Change Order #3

Regional Linear Park Phase II (Hike & Bike Trail)

Project: RLPPII
Contract: C-18-199-02-12
CSJ: 0921-02-409
Limits: Hall Acres to Ridge Road

Change Order #3 relocates the conduit, wire, drilled shafts and poles to the opposite side of the trail due to an easement conflict.

CKD:	MNR	CONT	SECT	JOB	HIGHWAY
CKDW:	RLM	0921	02	409	RLPP
CKTR:	HCS	DIST	COUNTY	SHEET NO.	
		PHR	HIDALGO	143

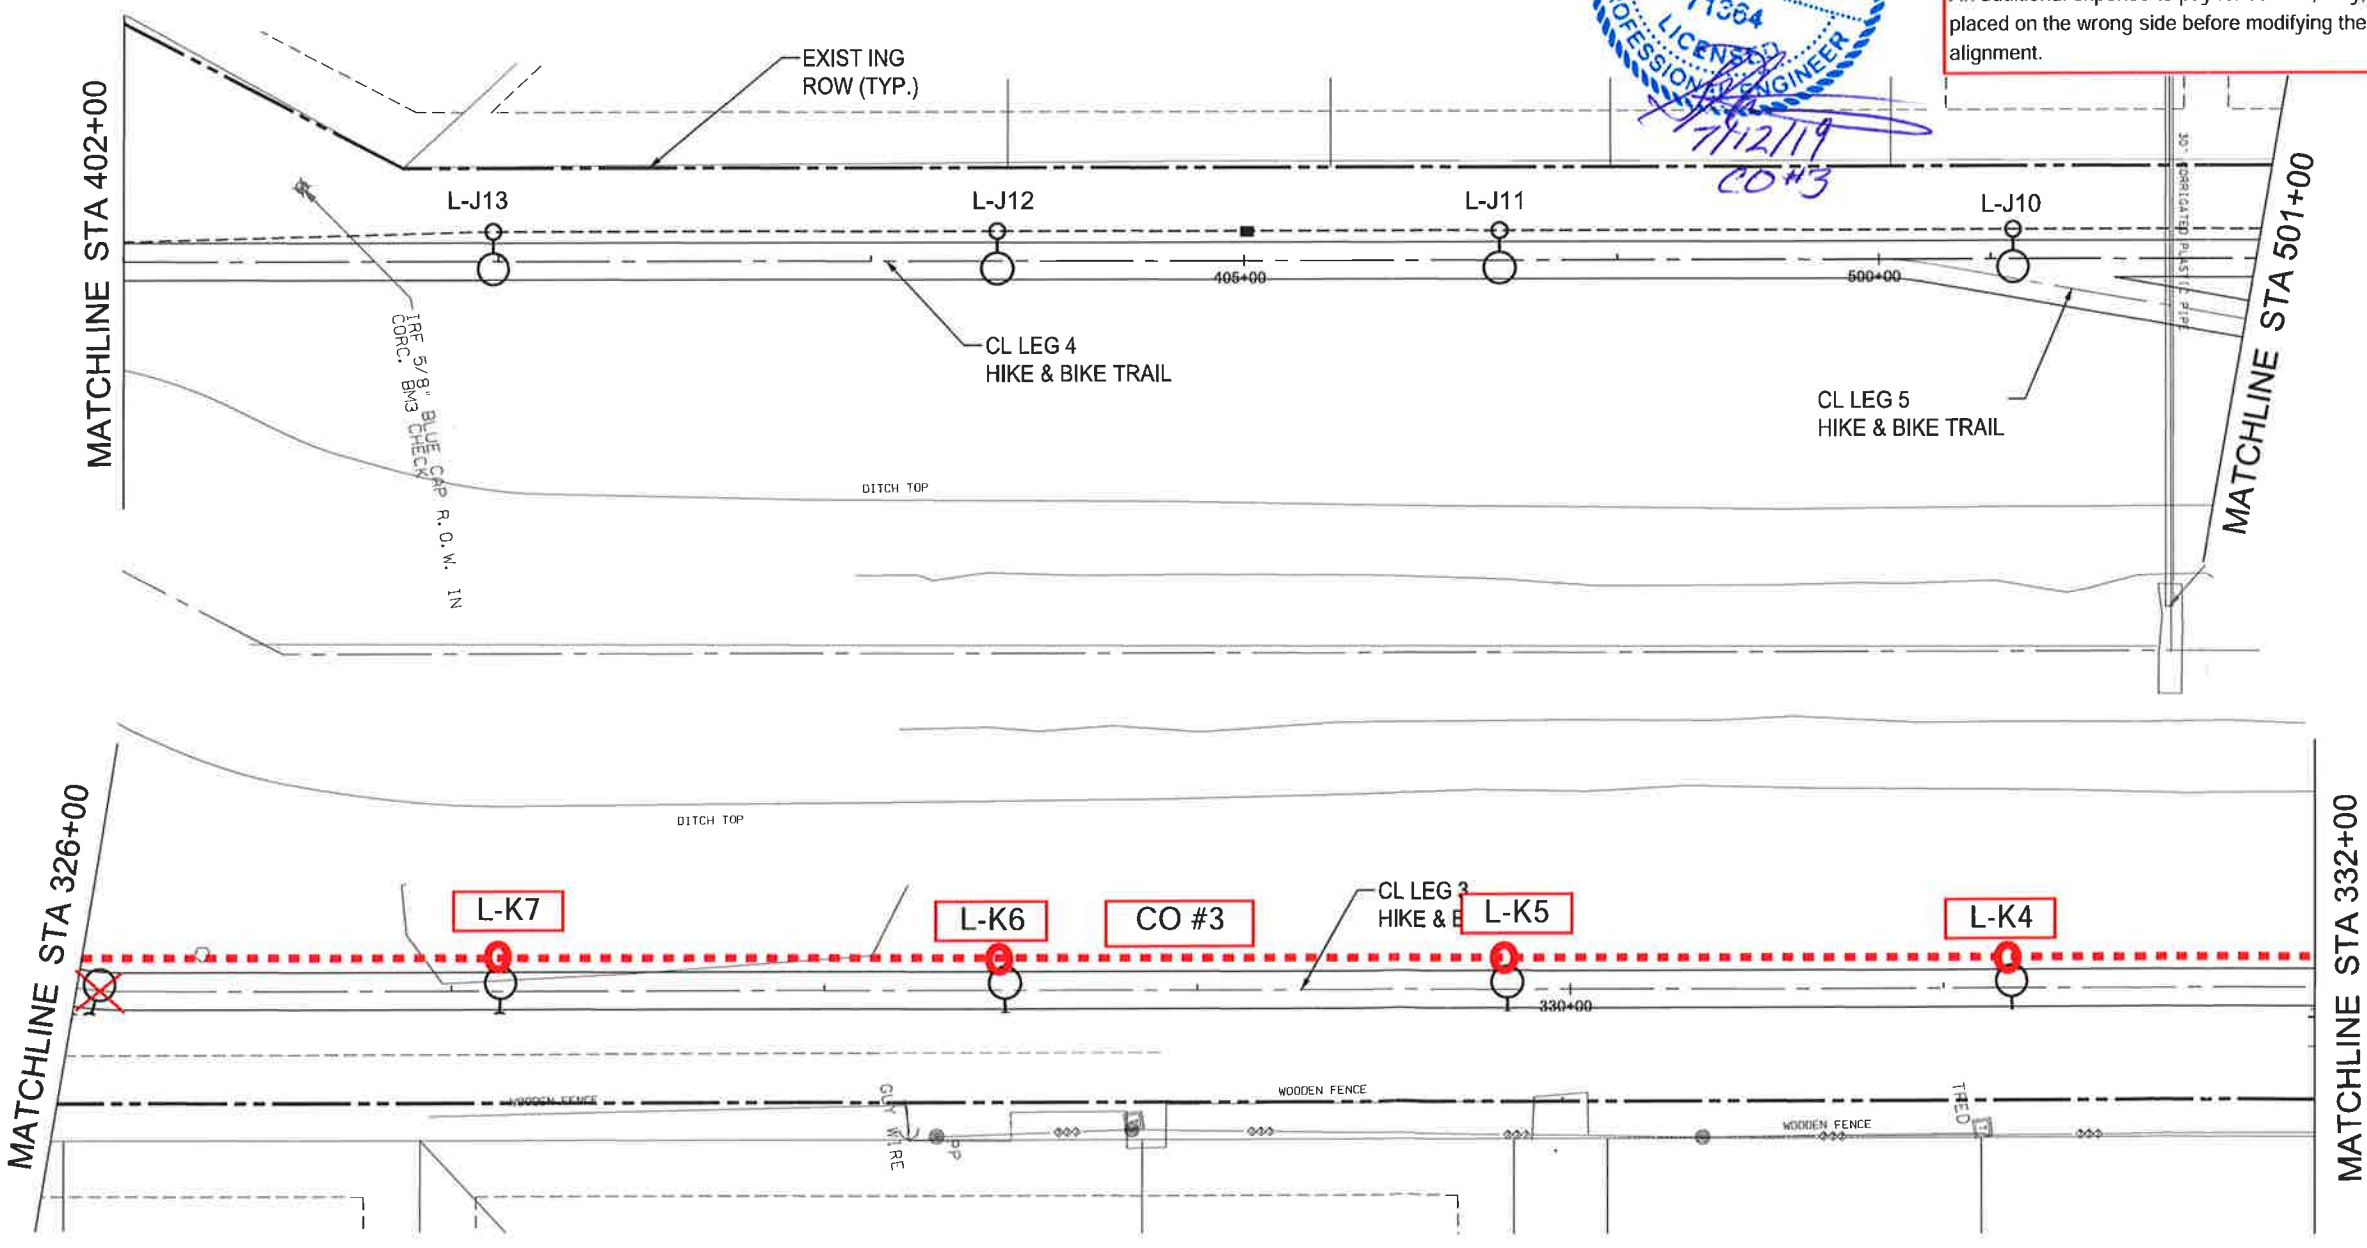
CO #3
 Plans did not account for existing utility easement adjacent to the hike and bike trail. In order to place conduit, wiring, poles and luminaires outside of the easement, the alignment will cross to the inside of the trail. Plan sheets were originally prepared by consultant L&G and modified by B2Z engineering. Modified to show new alignment. An additional expense to pay for conduit, only, placed on the wrong side before modifying the alignment.

Plans did not account for existing easement on the Hidalgo County Hike and Bike Plans between Ridge Road and the irrigation canal, south of Ridge Road on the east side of the canal, east of the trail. The easement was defined on a Right of Way map but not on the plans and the lighting and conduit was designed within the easement. The Engineer of Record verified that the easement was correct and decided to relocate the lighting to the west side of the trail. The error was identified early, but not before placing conduit, only. The change order redesigns the lighting between Sta 324+75 and 335+50, pays for the additional conduit and to place the line away on the opposite side of the trail.

Plans did not account for existing utility easement adjacent to the hike and bike trail. The alignment will have to cross to the inside of the trail to avoid the easement. Plan sheets were originally prepared by consultant L&G and modified by B2Z engineering that show new alignment. An additional expense is included to pay for 1080Lf conduit that placed in the easement before identifying the error and redesigning the alignment.

CK DR:	MNR	CONT	SECT	JOB	HIGHWAY
CK DW:	RLM	0921	02	409	RLPP
CK TR:	HCS	DIST	COUNTY	SHEET NO.	
		PHR	HIDALGO	142

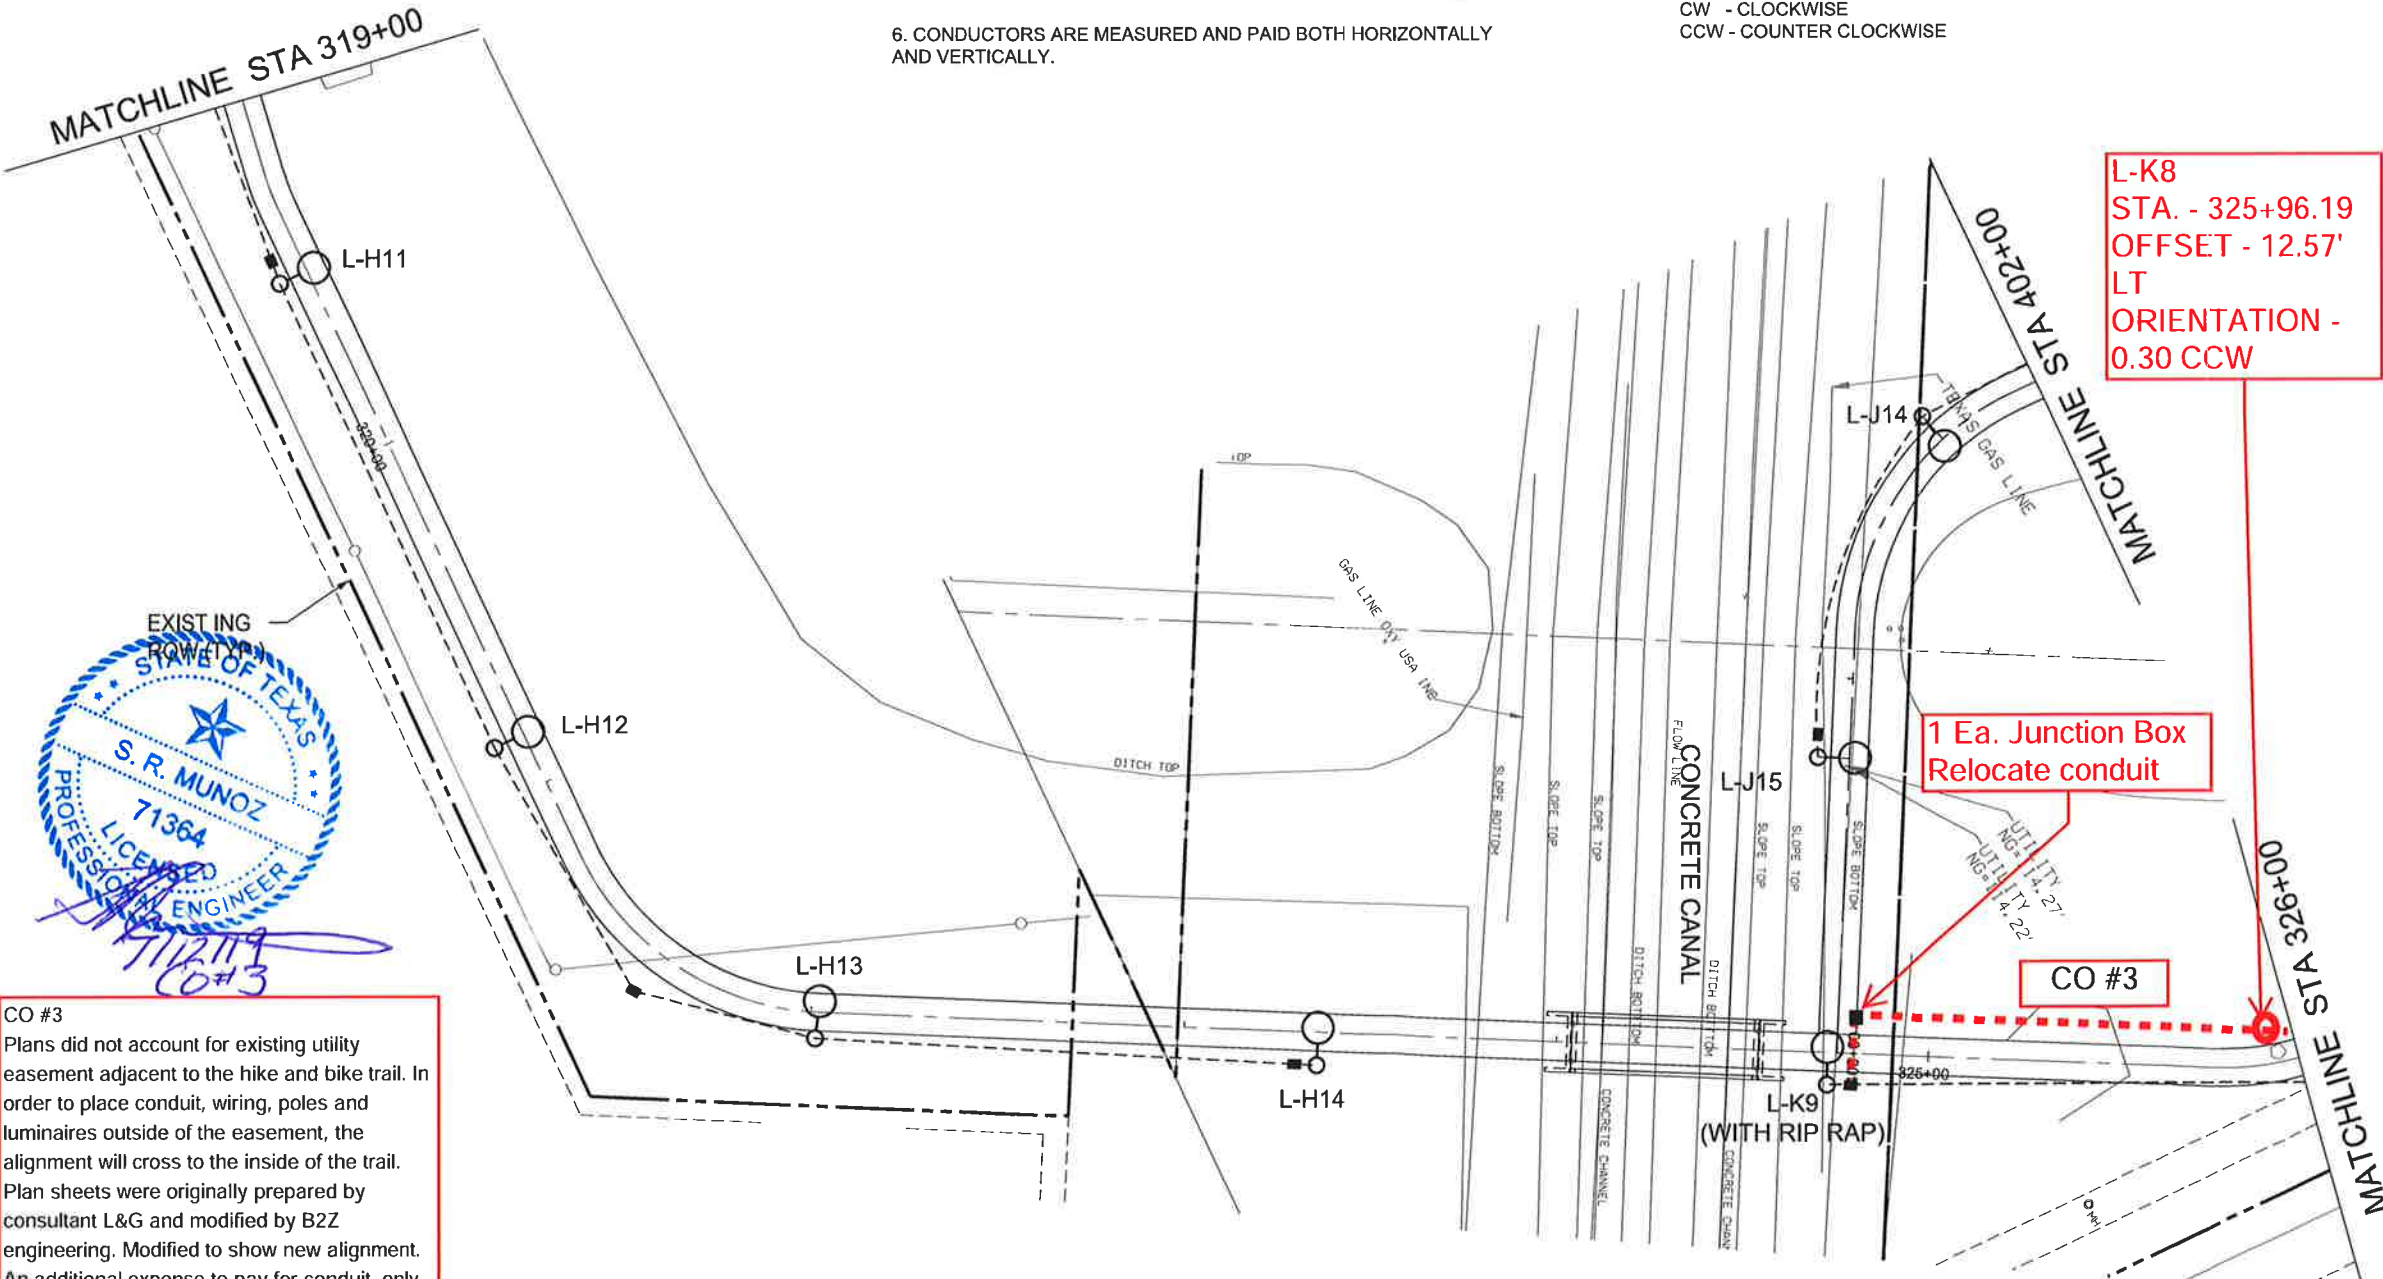
L-K8
 STA. - 325+96.19
 OFFSET - 12.57'
 LT
 ORIENTATION - 0.30 CCW

1 Ea. Junction Box
 Relocate conduit

CO #3
 Plans did not account for existing utility easement adjacent to the hike and bike trail. In order to place conduit, wiring, poles and luminaires outside of the easement, the alignment will cross to the inside of the trail. Plan sheets were originally prepared by consultant L&G and modified by B2Z engineering. Modified to show new alignment. An additional expense to pay for conduit, only placed on the wrong side before modifying the alignment.

CK DN:	MNR	CONT	SECT	JOB	HIGHWAY
CK DW:	RLM	0921	02	409	RLPP
CK TR:	HCS	DIST	COUNTY	SHEET NO.	
		PHR	HIDALGO	142

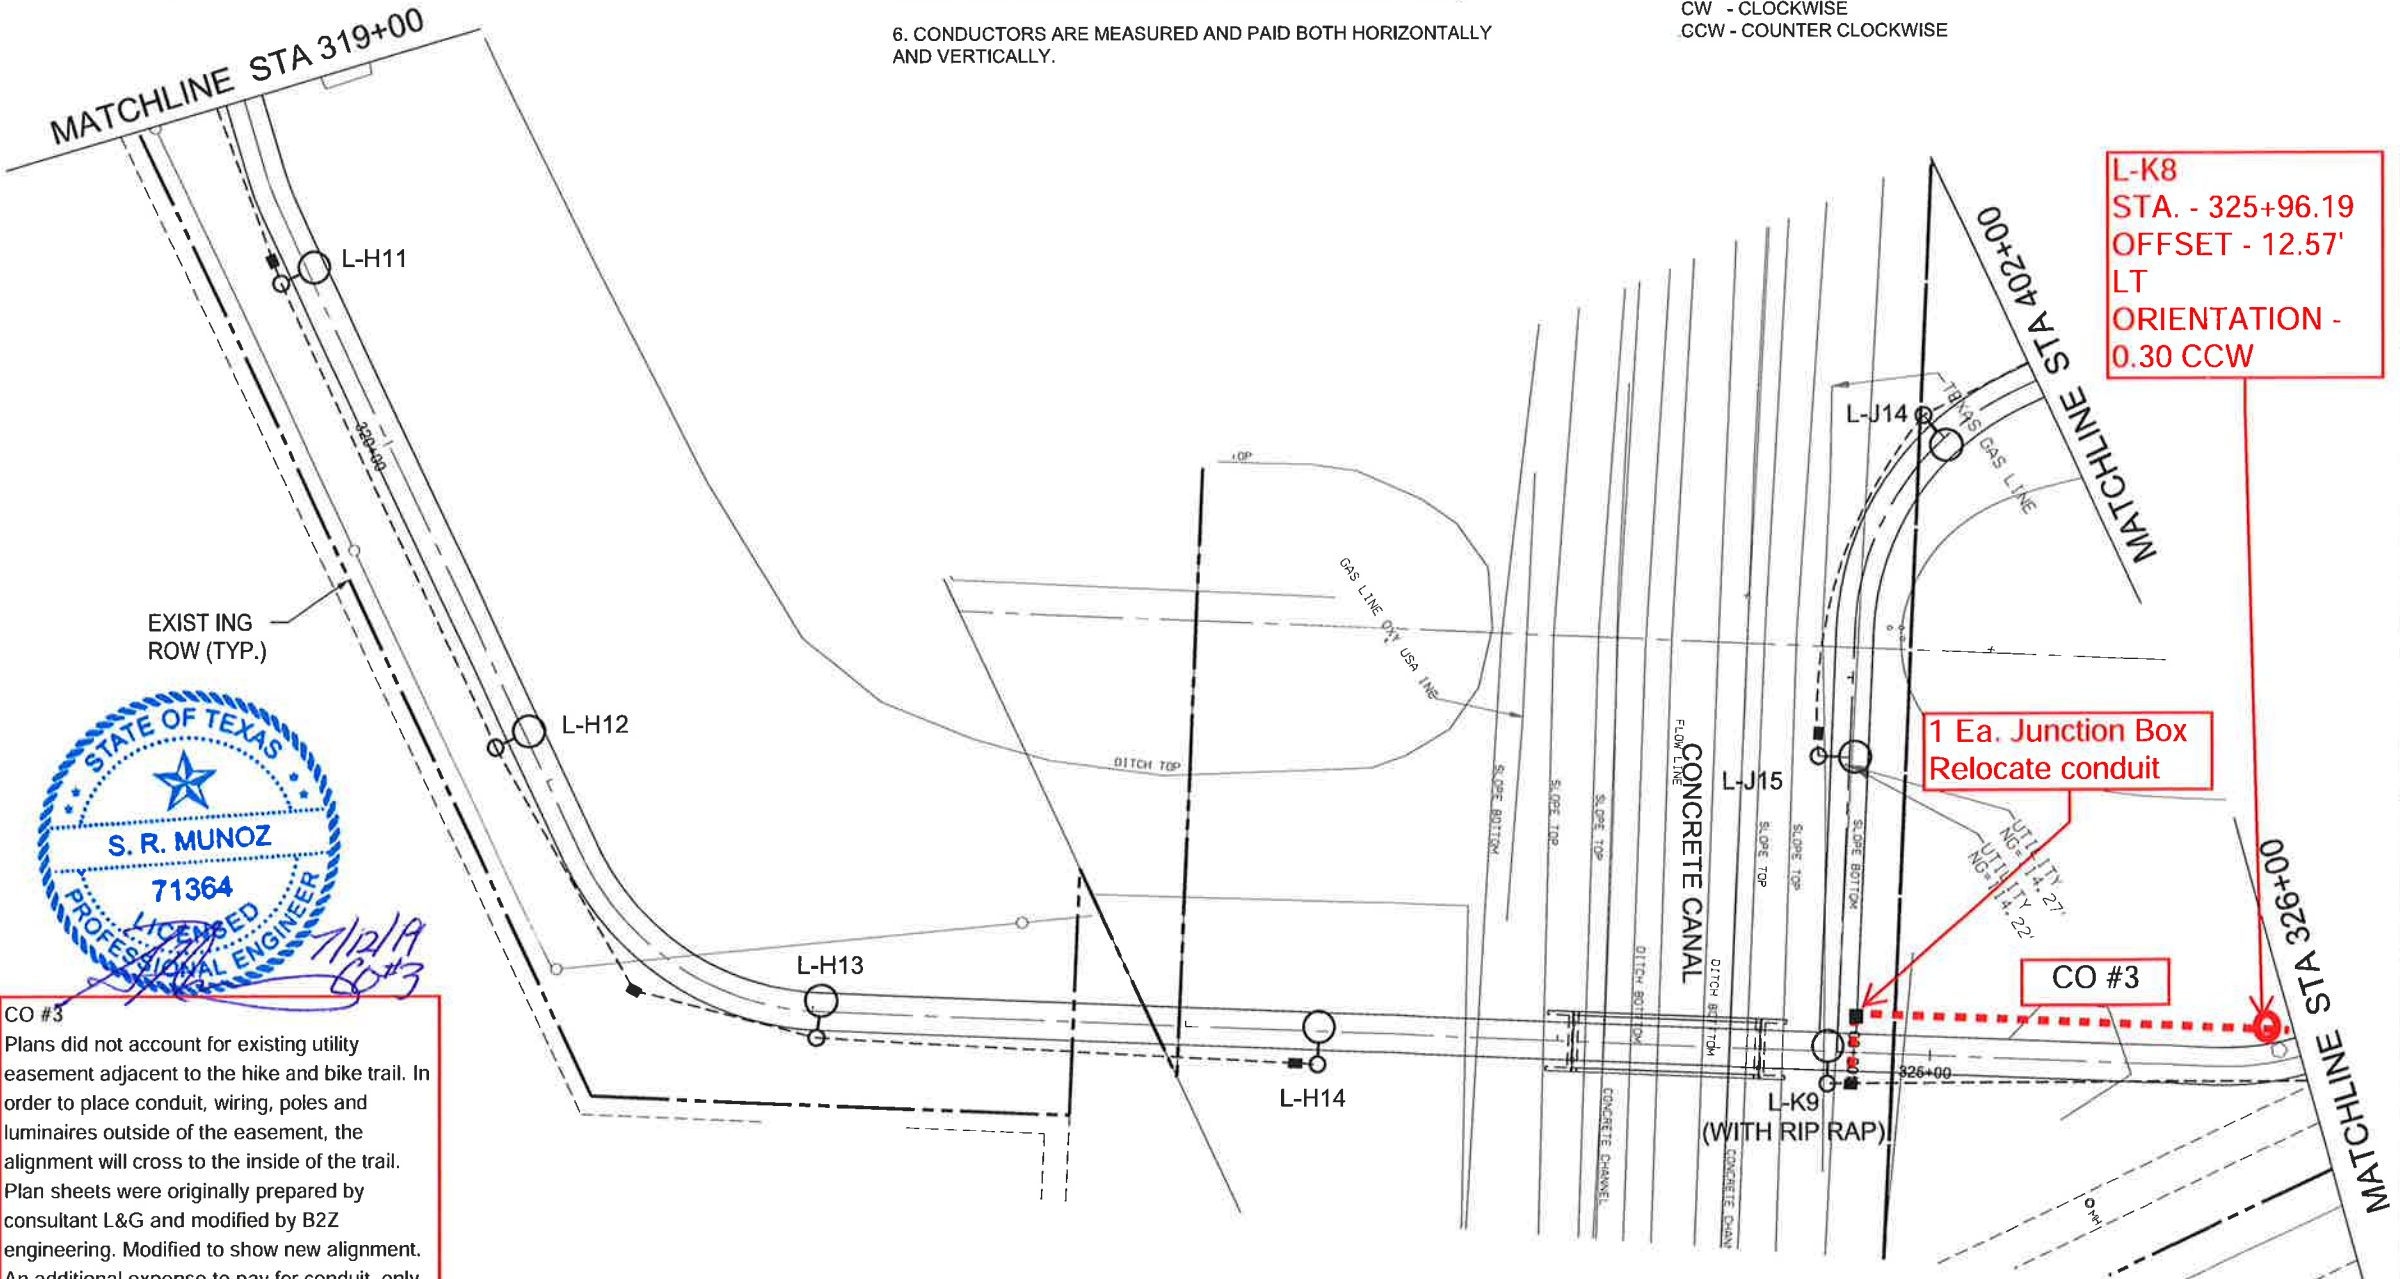
CO #3
 Plans did not account for existing utility easement adjacent to the hike and bike trail. In order to place conduit, wiring, poles and luminaires outside of the easement, the alignment will cross to the inside of the trail. Plan sheets were originally prepared by consultant L&G and modified by B2Z engineering. Modified to show new alignment. An additional expense to pay for conduit, only, placed on the wrong side before modifying the alignment.
